TITLE: **2019 MOUNTAIN AIRE**
 87" HOME THEATER
 2 RECLINERS - CENTER CONSOLE

DWG. NO.: **VI7000389**

REV. **J**

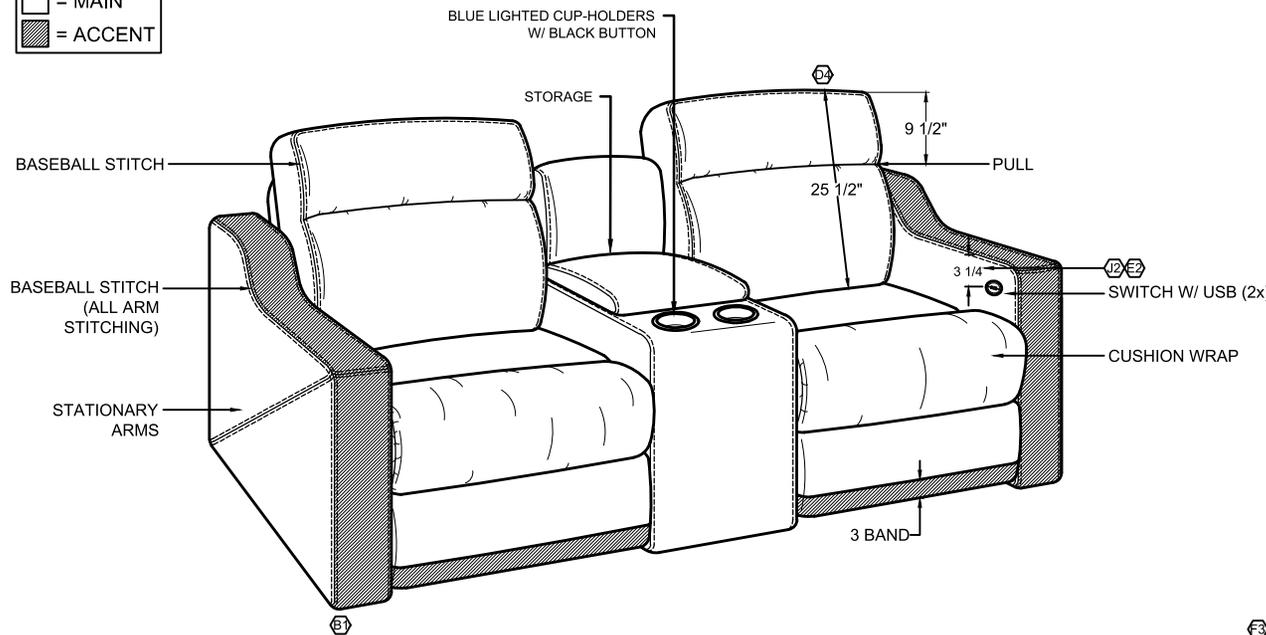
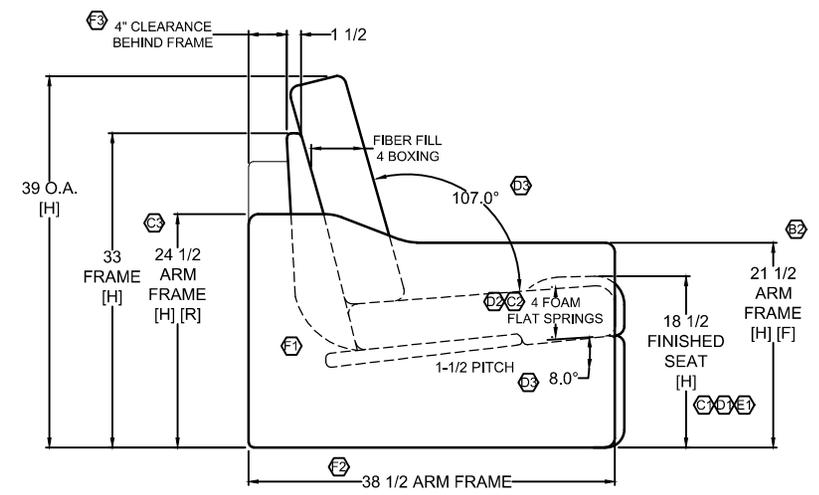
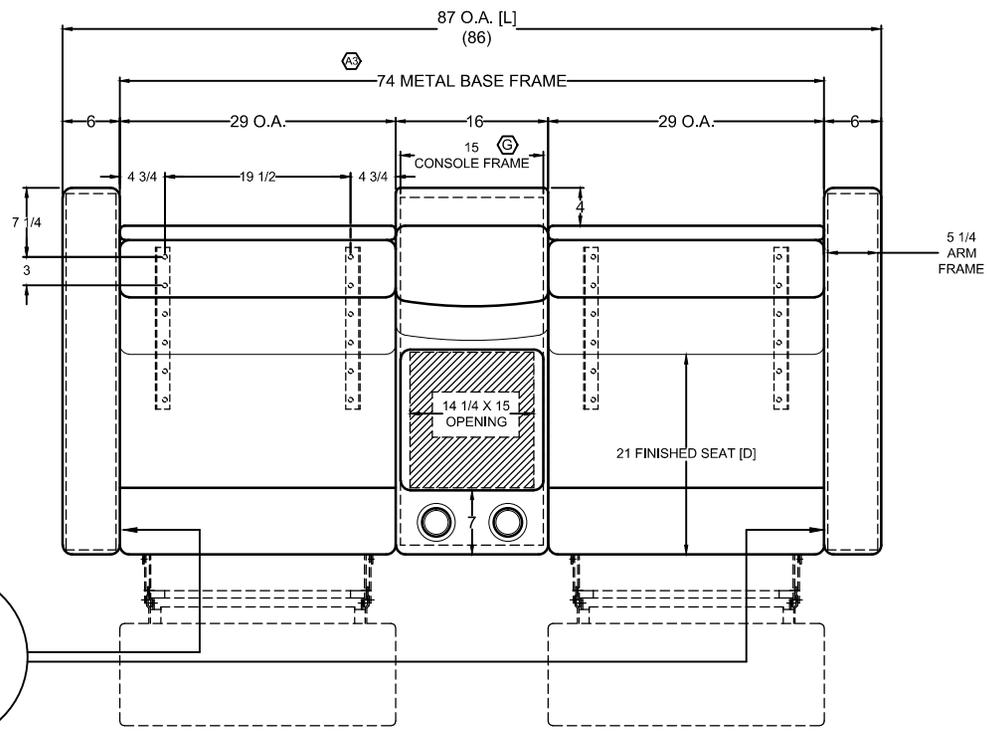
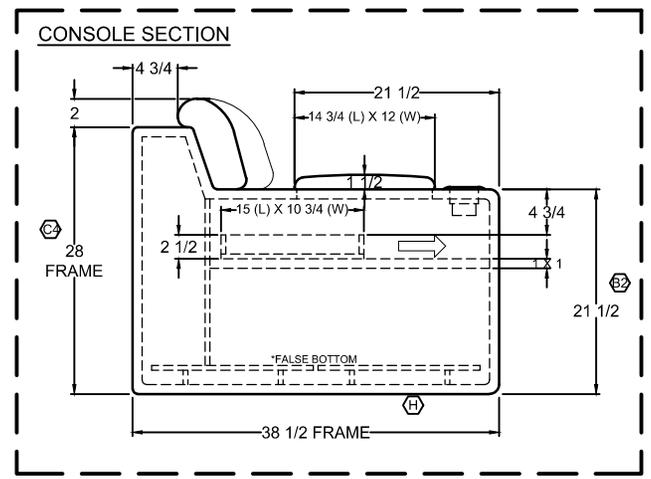
REV.	DESCRIPTION	DATE
JA J	[1] REMOVE BASEBALL STITCH FROM INSIDE OF ARMS, [2] CHANGE SWITCH PLACEMENT FROM TOP OF ARM TO 3-1/4"; WAS 5-1/4". (REF. ECO #089-2019)	08.08.19
JA H	ADD FALSE BOTTOM TO MIDDLE CONSOLE. (REF. ECO #018-2019)	07.26.19
LB G	PRODUCTION UPDATE: CHANGED THE WIDTH OF THE CONSOLE FRAME TO 15"; WAS 15 1/4".	04.25.19
JA F	PRODUCTION UPDATE: [1] ADJUST BACK FRAME RENDERINGS ON SIDE VIEW, [2] REMOVED O.A. DEPTH AND ADDED 38-1/2" ARM FRAME DEPTH TO DRAWING, [3] ADJUSTED CLEARANCE ON SIDE VIEW, [4] ADDED 74" METAL BASE FRAME WIDTH TO DRAWING.	01.16.19
JA E	PER RL, [1] CHANGE SEAT HEIGHT TO 18-1/2"; WAS 18". [2] ADD 5-1/4" HEIGHT DIMENSION FROM TOP OF ARM TO USB SWITCH.	11.27.18
JA D	PER RL, [1] CHANGED SEAT HEIGHT TO 18"; WAS 19-1/2". [2] CHANGED SEAT FOAM TO 4"; WAS 5". [3] ADDED 8" ANGLE DIMENSION TO BOTTOM OF SEAT AND 107° ANGLE DIMENSION TO TOP OF SEAT AND BACK. [4] ADDED 25-1/2" HEIGHT DIMENSION TO BACK PILLOW.	11.21.18

JA C	PRODUCTION UPDATE: [1] CHANGE SEAT HEIGHT TO 19-1/2"; WAS 18". [2] CHANGE SEAT CUSHION FOAM TO 5"; WAS 4". [3] CHANGED BACK ARM FRAME HEIGHT TO 24-1/2"; WAS 26-1/2". [4] CHANGED BACK CONSOLE FRAME HEIGHT TO 28"; WAS 30".	11.06.18
JA B	PER RL, [1] ADD ACCENT TO FRONT OF ARM. [2] REDUCED ARM AND CONSOLE FRAME HEIGHT TO 21-1/2"; WAS 23-1/2".	11.02.18
JA A	PER PRODUCTION, REMOVED ARM FRAME DIMENSION DESCRIPTION FROM DRAWING.	10.31.18
